Reading Borough Council Wensley Road : New Build & Estate Improvements Phase 1

Post-planning Design Changes Report

RBC-WLR-HTA-A_XX_XX_RP_1790

March 2022

Block A - Current GA Plan

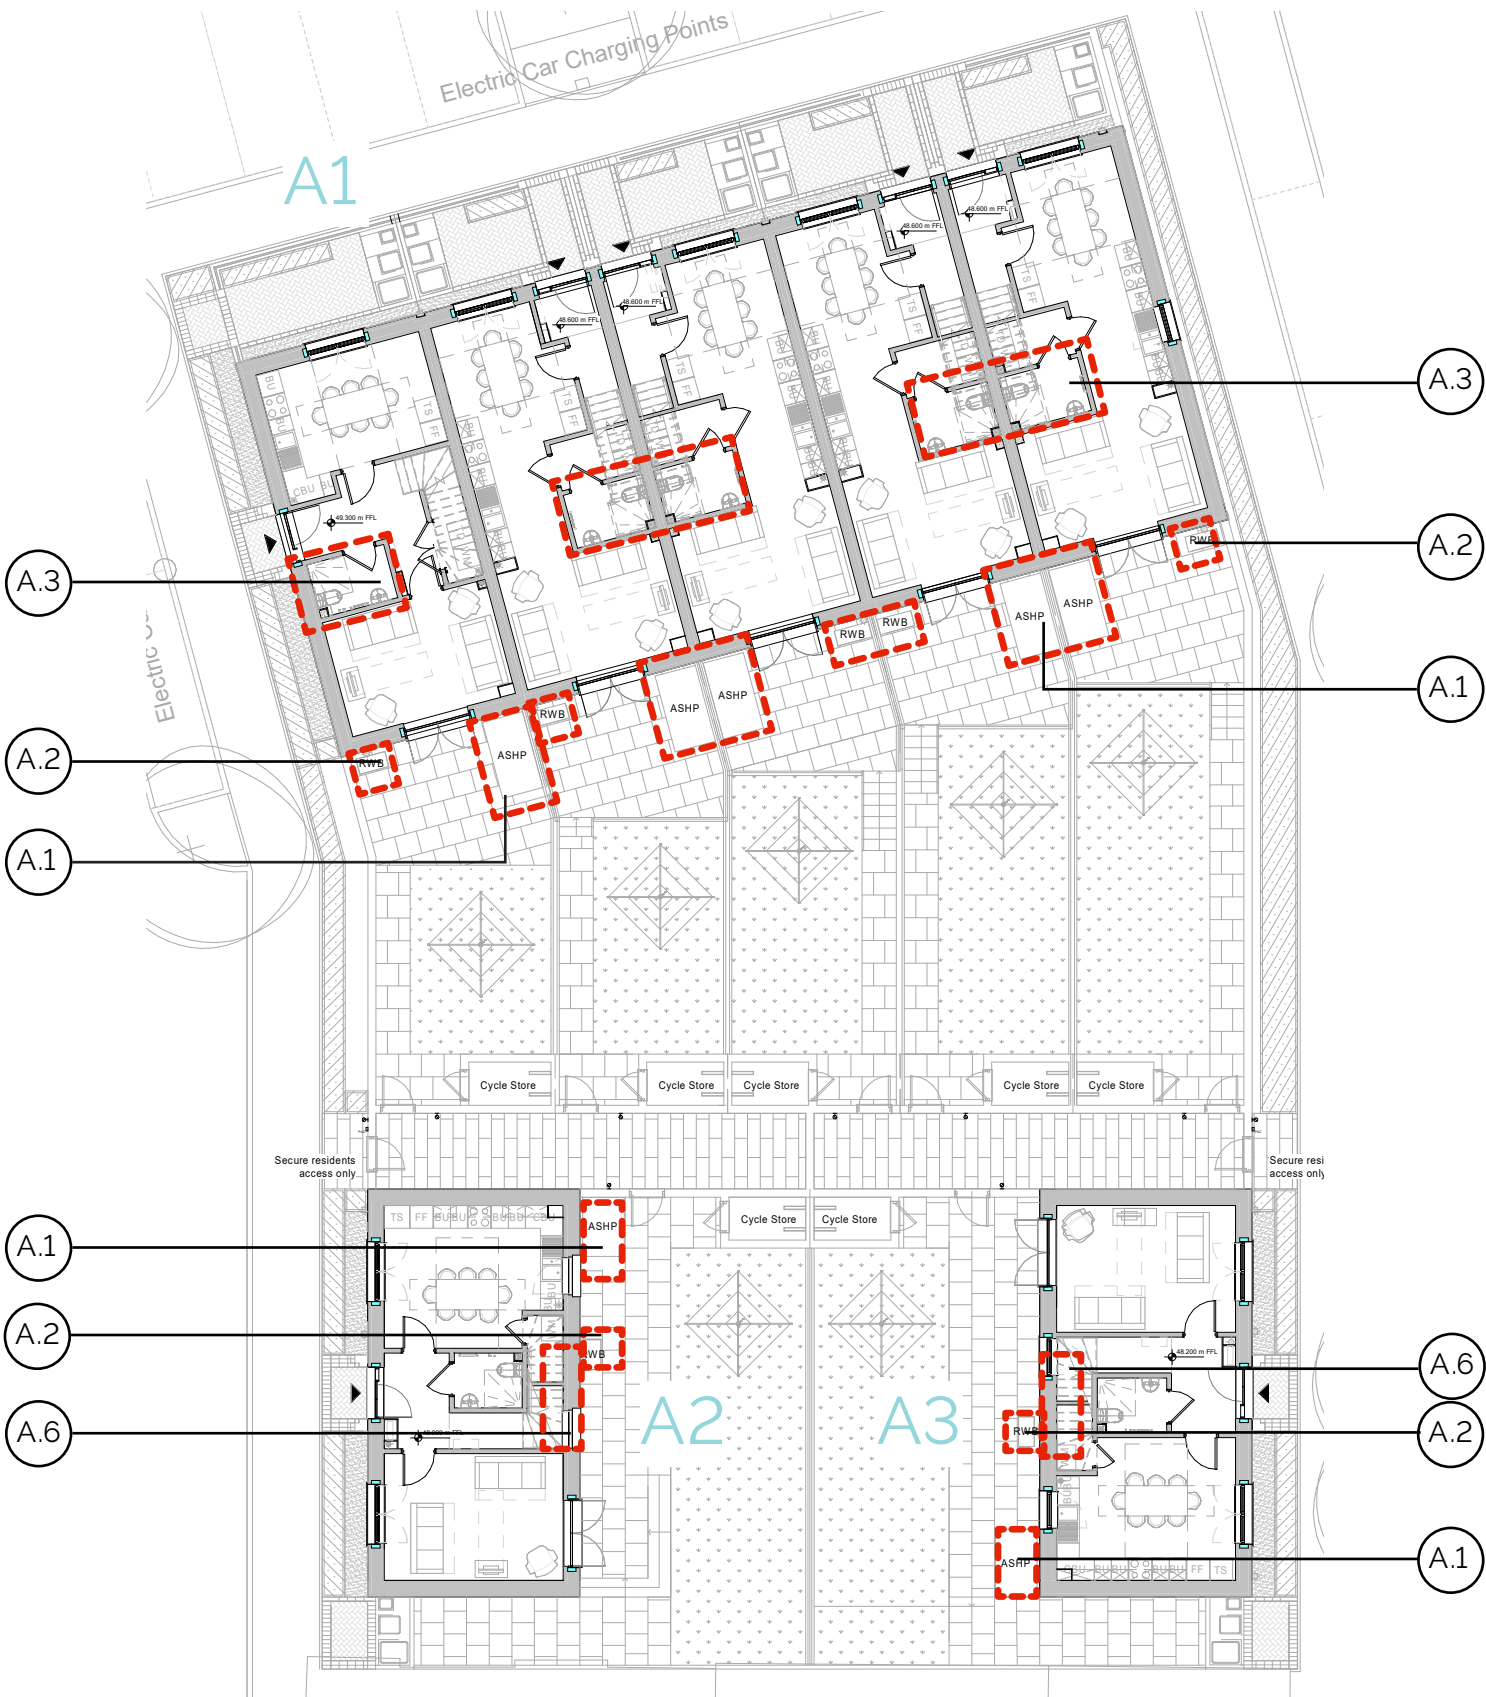
A.1	ASHP moved within the rear garden, adjacent to the houses
A.2	Water butts and additional rainwater pipes added
A.3	Ground floor WC increased to meet M(4) requirements
A.4	Ground floor WC and entrance door flipped to resolve internal layout
A.5	Material of individual refuse stores changed from brick to perforated metal
A.6	Roof light to stairs omitted and replaced with window on the rear elevation
A.7	A2 Ground FFL changed from 48.700 to 48.900. Upper floor FFLs and ridge height also raised by 200mm.
A.8	Minor Amendments to parapet and ridge heights
A.9	Satellite dishes added
A.10	Brick soldier detailing removed above window on rear elevation

Block A1 South Elevation - Planning

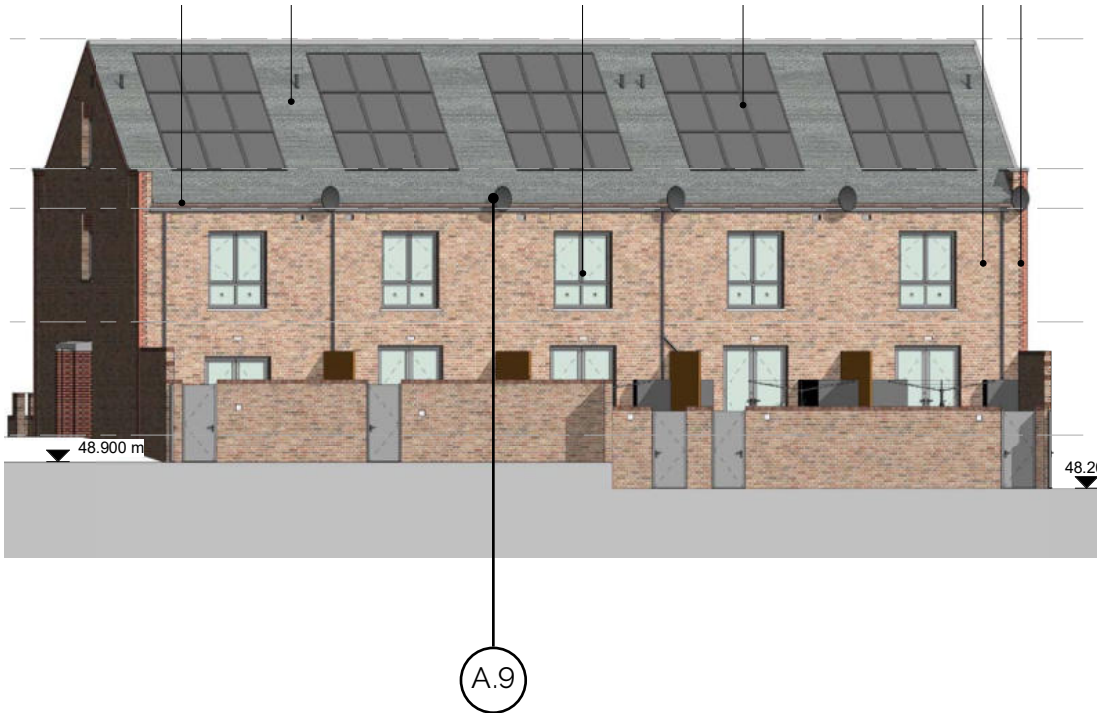
A.1	ASHP moved within the rear garden, adjacent to the houses
A.2	Water butts and additional rainwater pipes added
A.3	Ground floor WC increased to meet M(4) requirements
A.4	Ground floor WC and entrance door flipped to resolve internal layout
A.5	Material of individual refuse stores changed from brick to perforated metal
A.6	Roof light to stairs omitted and replaced with window on the rear elevation
A.7	A2 Ground FFL changed from 48.700 to 48.900. Upper floor FFLs and ridge height also raised by 200mm.
A.8	Minor Amendments to parapet and ridge heights
A.9	Satellite dishes added
A.10	Brick soldier detailing removed above window on rear elevation

Block A1 West Elevation - Planning

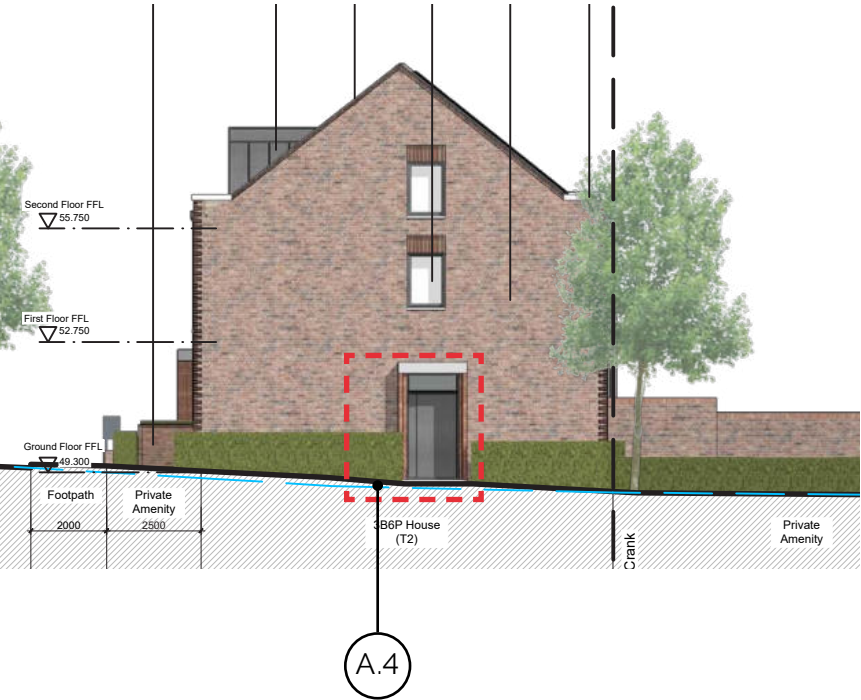
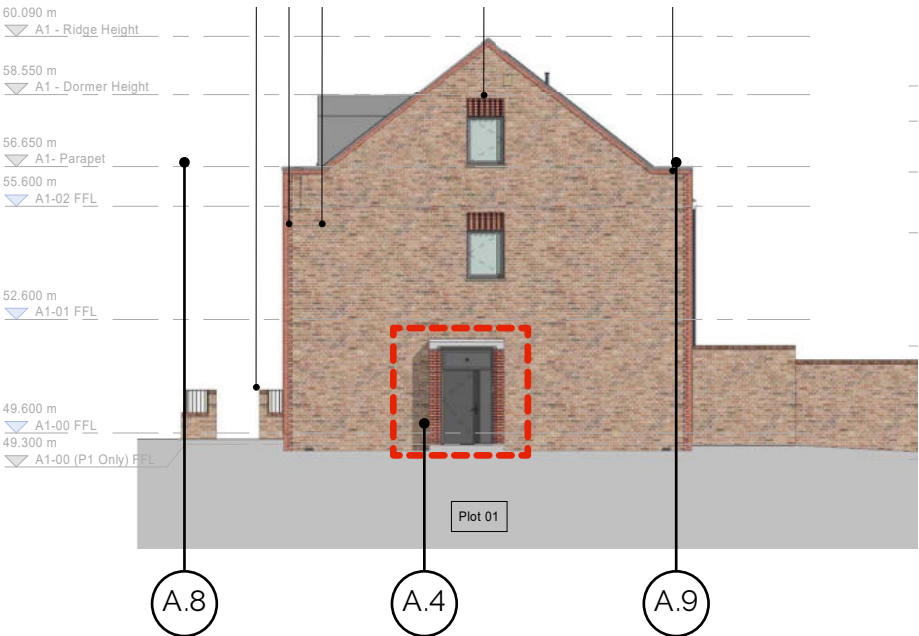
A.1	ASHP moved within the rear garden, adjacent to the houses
A.2	Water butts and additional rainwater pipes added
A.3	Ground floor WC increased to meet M(4) requirements
A.4	Ground floor WC and entrance door flipped to resolve internal layout
A.5	Material of individual refuse stores changed from brick to perforated metal
A.6	Roof light to stairs omitted and replaced with window on the rear elevation
A.7	A2 Ground FFL changed from 48.700 to 48.900. Upper floor FFLs and ridge height also raised by 200mm.
A.8	Minor Amendments to parapet and ridge heights
A.9	Satellite dishes added
A.10	Brick soldier detailing removed above window on rear elevation

3.1 Block B
GA Plan

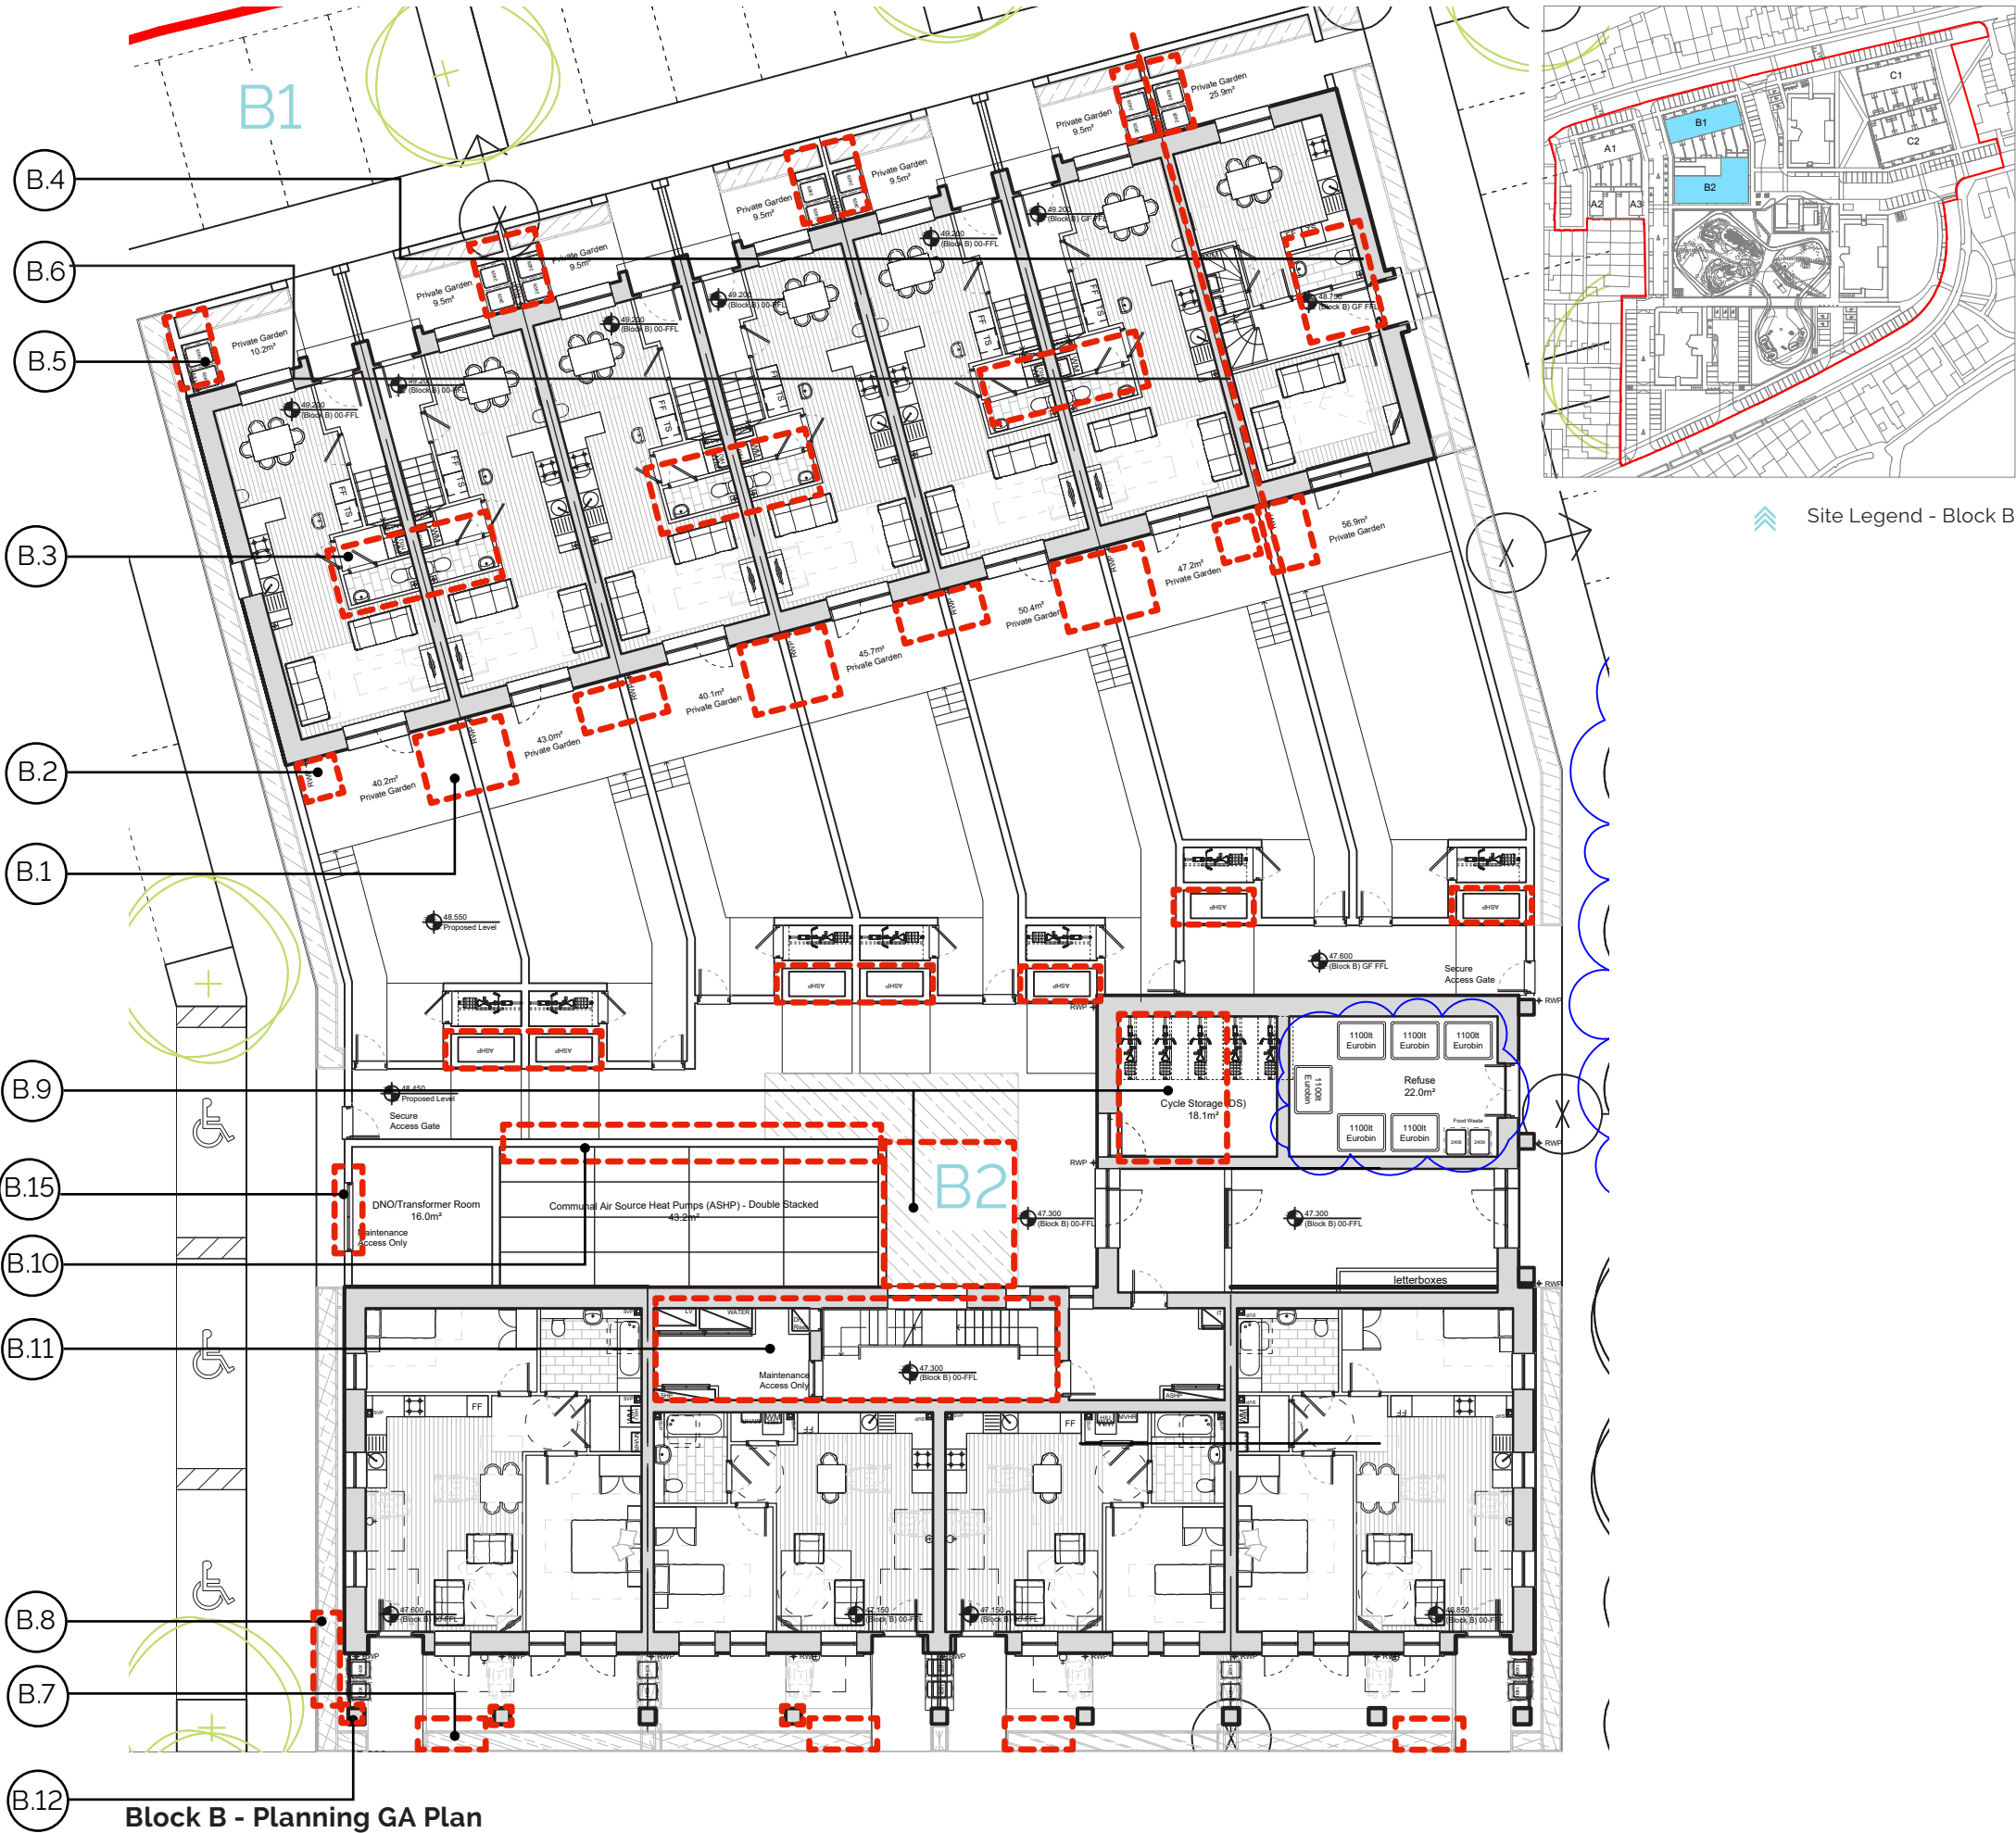
B.1	ASHP moved within the rear garden, adjacent to the houses.
B.2	Water butts and additional rain water pipes added.
B.3	Ground floor WC increased to meet M(4)2 requirements.
B.4	Ground floor WC and entrance door flipped to resolve internal layout.
B.5	Material of individual refuse stores changed from brick to perforated metal.
B.6	Step in ground floor FFL increased from 450mm to 750mm
B.7	Location of individual refuse store to ground floor flats amended.
B.8	Refuse presentation points added.
B.9	Communal Cycle store relocated to provide pram store internally.
B.10	Communal ASHP enclosure changed from brick to acoustic louvres.
B.11	Communal staircore reconfigured in accordance with AD Part B , with window locations and sizes amended to suit.
B.12	Columns to apartment block increased from 440mm to 625mm .
B.13	Change to third floor balcony, east and west elevation from metal railings to brick.
B.14	Juliette balconies replaced with window and brick panel below.

B.15	Access to water tank relocated to rear garden access route.
B.16	Obscured bedroom windows omitted. Windows added to refuse stores.
B.17	Minor Amendments to parapet and ridge heights.
B.18	Satellite dishes added.
B.19	PV panels removed from B2 east roof due to overshadowing
